工程指示 / 要求簡箋 ENGINEER INSTRUCTIONS(E.I.)

工程指示編號:	EI- 5844	修改版本:	-
	HK- 0456		
工程編號:	J 859	工程名稱:	NKIL 6551
收件人:	生統 / 林仁安	發件人:	Edwin Ho
工程項目:	佛沙窗加工指示更新 (總代理人)	日期:	14/03/2023

JOB NO. : J-859
 PROJECT : PROPOSED RESIDENTIAL / COMMERCIAL DEVELOPMENT AT NKIL NO.6551 KAI TAK AREA 4C, SITE 3 KAI TAK, KOWLOON
 TITLE : TYPICAL ASSEMBLY DETAILS OF ALUM. WINDOW

美特鋁質有限公司
MIDI ALUMINIUM FABRICATOR LTD.
 Units 6-8, Sunray Industrial Centre, 1/F
 610 Cha Kwo Ling Road, Kowloon
 Tel:23489211-4 Fax:(852)2727866
 DWG NO. : J859-SD-PW-DT85a REV. : E

2 DETAIL OF MAX. WINDOW OPENING

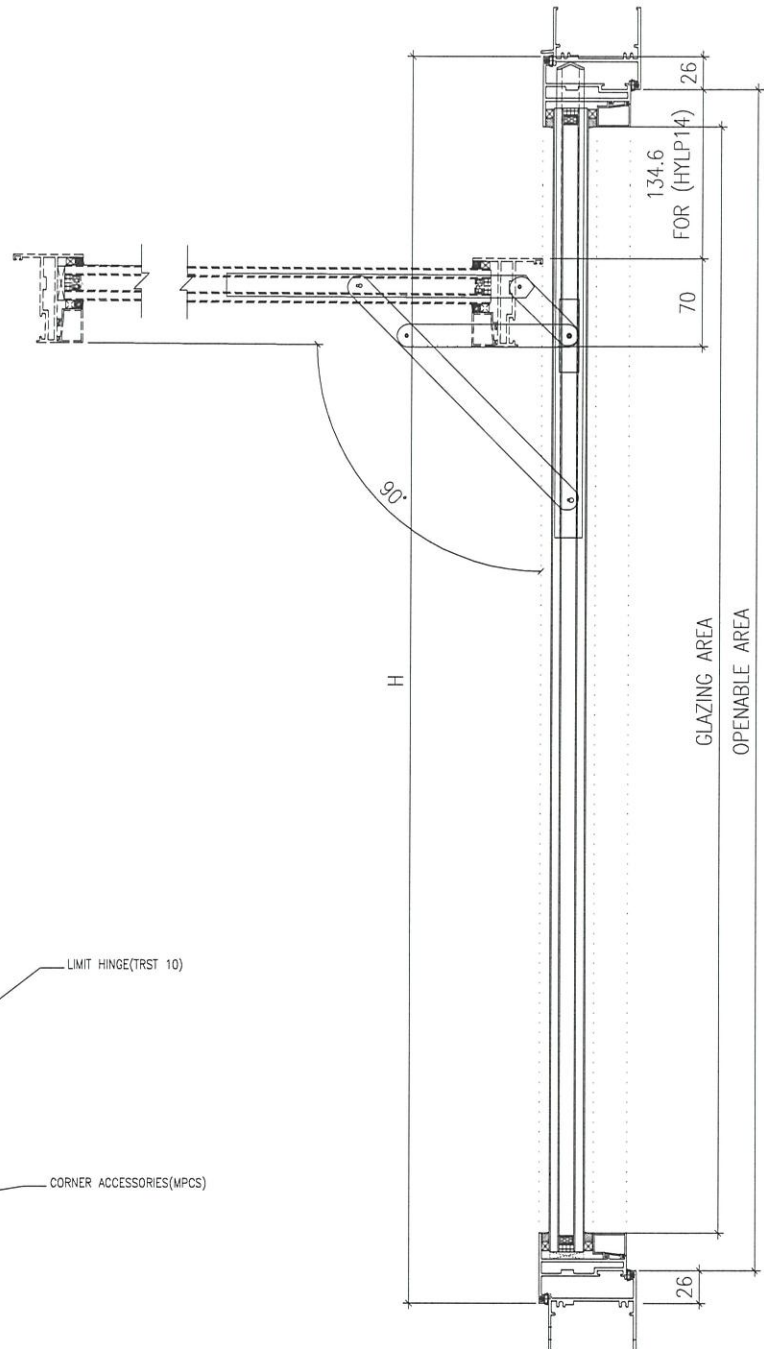
1. 反拍線Keep 4mm
2. 上懸窗窗邊開關空間上限為100mm
3. 上懸窗下方左右均新增斜傍膠粒

關閉限
位數為：
100mm

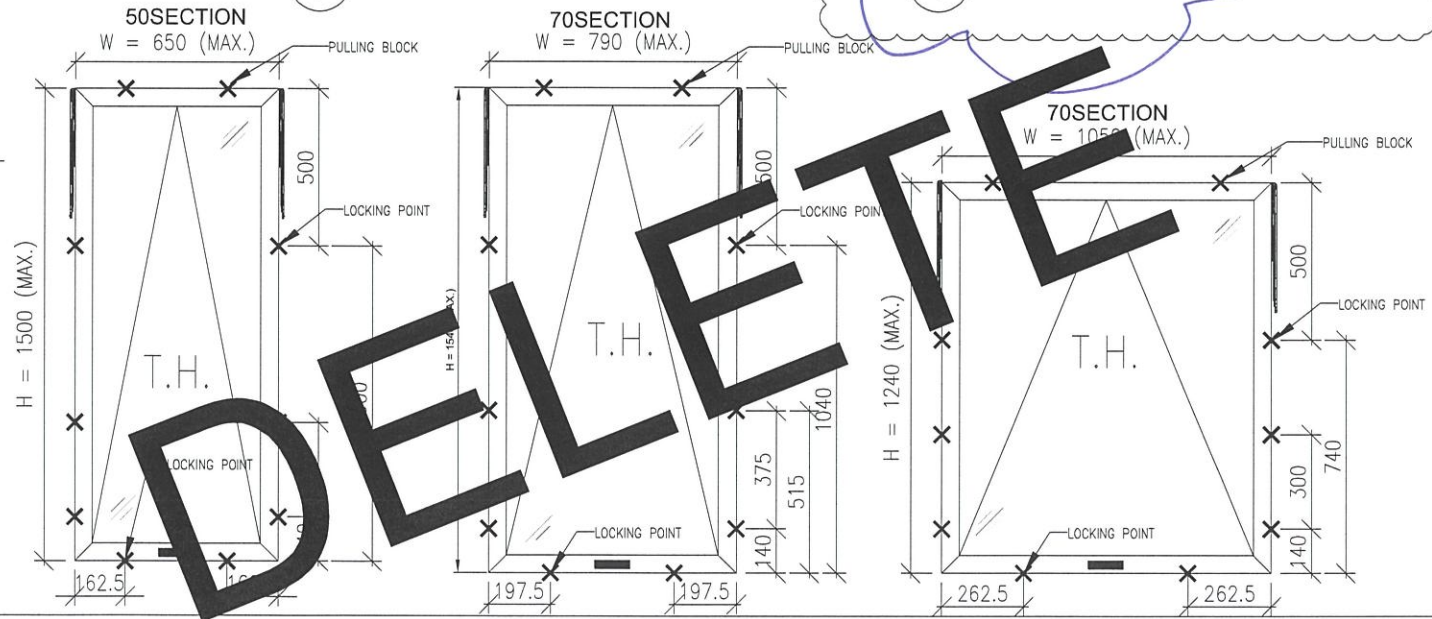
DELETE

斜倚膠
